**Item 3.****D/2023/997: 422-424 Cleveland Street, Surry Hills****File No.: D/2023/997****Summary**

**Proposal Summary:** The application seeks consent for alterations and additions to the existing 'Kirk' church building to deliver a commercial development with a five storey rear addition and excavation to create a single level basement.

**Summary Recommendation:** The development application is recommended for approval, subject to conditions.

Figure 25: Proposed East Side Elevation (High Holborn Street)

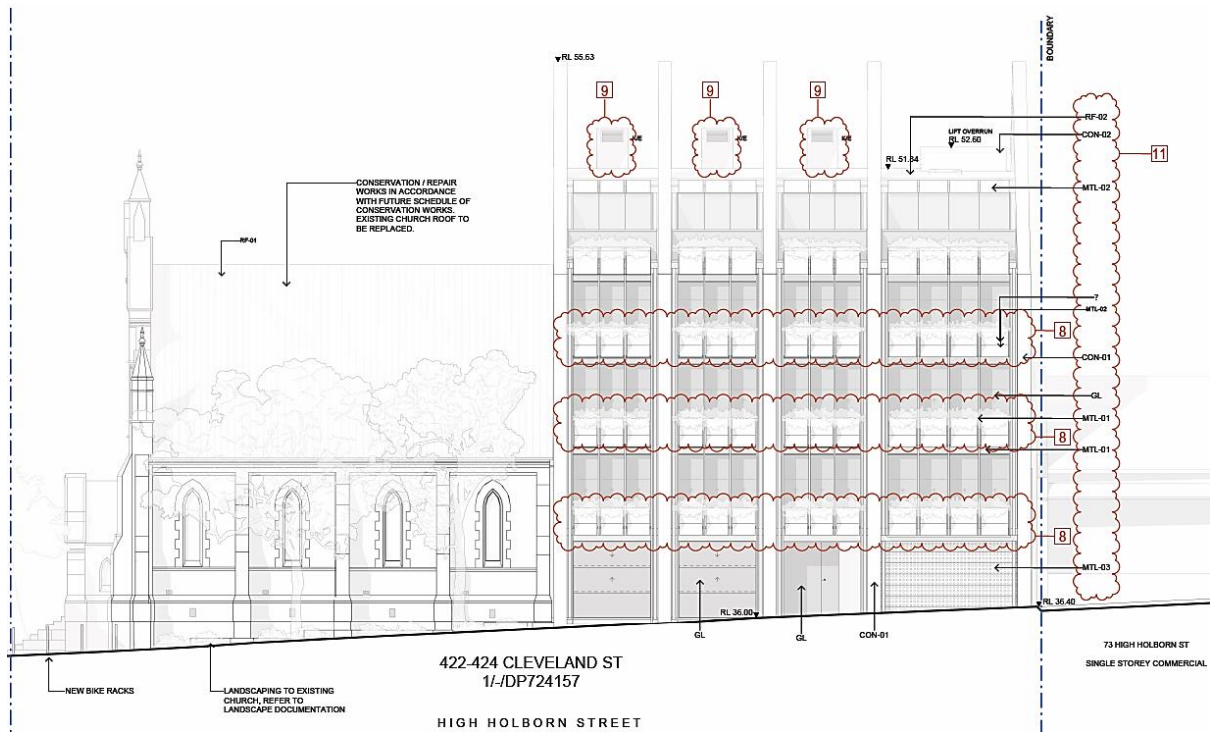
94. Notwithstanding the above, further privacy treatments are recommended to the eastern elevation as these large windows currently provide direct and largely unfettered views towards the residential windows and private open spaces of west facing apartments within No.426 Cleveland Street.

**Figure 36:** Diagram showing LEP 15m height plane and proposed development's areas of non-compliance with the Height of Buildings development standard

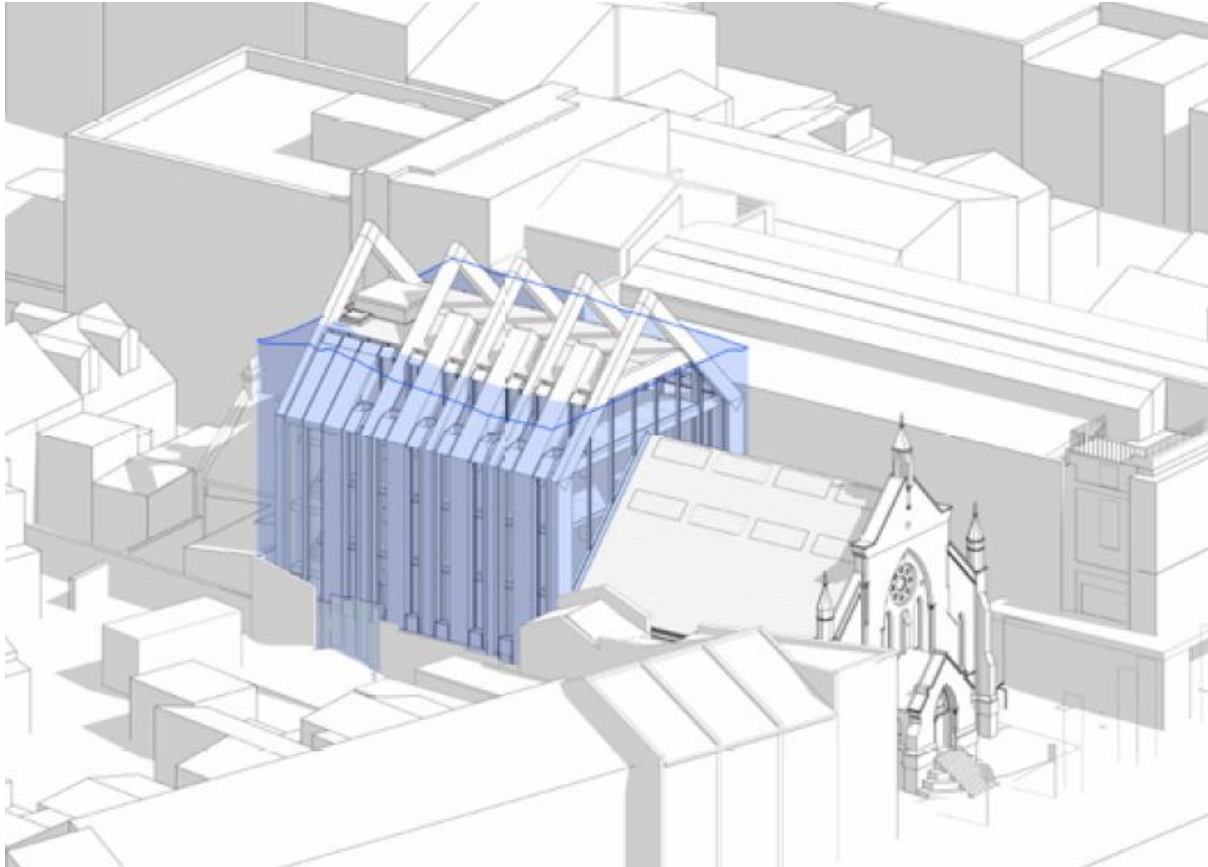
60. The site is subject to a maximum Height of Buildings development standard of 15 metres pursuant to Clause 4.3 of the Sydney LEP.
61. The proposed development has a maximum height of 19.53 metres to the top of the open pitched portal architectural roof features and a maximum building height of 16.6 metres to the top of the lift overrun.

62. It should be noted that for the purpose of calculating the maximum building height, the top points of the vertical kitchen exhaust risers were not included as they are considered to be “flues”, which are excluded in the LEP building height definition.
63. The diagram below illustrates the LEP 15 metre height plane across the site and highlights the parts of the development in breach of the development standard.

77. For the reasons provided above the requested variation to the Height of Buildings development standard is supported as the applicant's written request has adequately addressed the matters required to be addressed by cl 4.6 of the Sydney Local Environmental Plan 2012.

**Figure 38:** 3D perspective of west elevation illustrating columns and vertical exhausts integrated into the design and providing a greater solid to void ratio along this elevation to mitigate overlooking of residential properties to the west

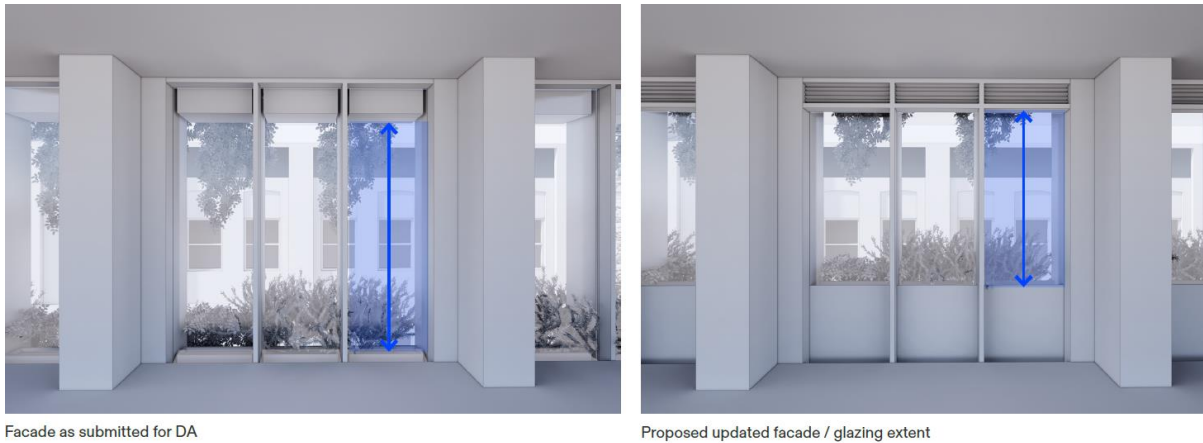
101. Amendments made by the applicant during assessment involving increasing the height of horizontal planters and associated raising of window sill heights are effective in mitigating downward views from the west elevation of the commercial tenancies at Levels 1 to 3 towards the rear yards and residential windows of terraces to the west.
